# SERVICE INFO

## Design change for deflection pulley 532 0433 10

**Part No.:** 532 0433 10

Deflection pulley 532 0433 10, previous design (A) and new design (B)

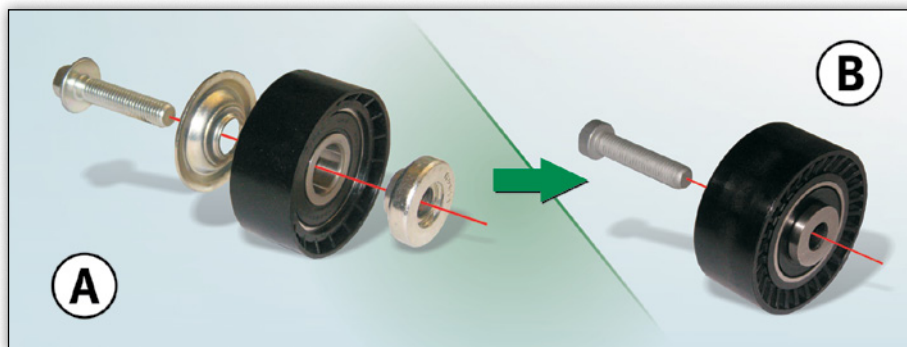
The design of deflection pulley 532 0433 10 has been modified as part of our efforts to continuously develop our products.

In the new design, the plate and spacer (Image 1, A) are no longer delivered as individual items as was previously the case. These components have been integrated in the new variant (Image 1, B) and are now an integral part of the deflection pulley.

During the transition period, we may have mixed stocks of both types. Both versions meet the relevant technical specifications and can be used without restrictions.

The deflection pulleys under A and B (see image) must only be mounted using the bolt provided.

Pulley A: M10x45, hex. bolt with collar  
Pulley B: M10x45, Torx bolt
